SERVICE BULLETIN No. 300-1-93

Subject: Rudder Control Cable Compression Sleeve

Models affected: EA-300, EA-300/S

Figure 1. Correct width of sleeves after compression.

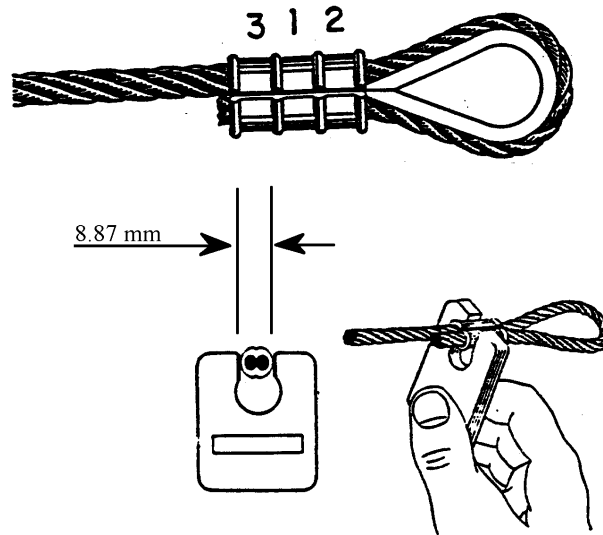
- Check rudder control cable compression sleeve according to AC 43.13-1A and Nicopress[®] Operating Instructions. Please refer to the attached sketch for the measurement.
- If change of compression sleeve is found to be necessary, change entire control cable. In any case use correct aligned Nicopress[®] tool and compression sleeves only.
- Make appropriate entry of compliance with this Service Bulletin in aircraft logbook.

Note: Compression sleeves are used on both ends of both control cables.

The rudder control cable is a 1/8" MIL, W-83420 7*19 type.

The compression sleeves are Nicopress[®] plain copper 18-3-M type.
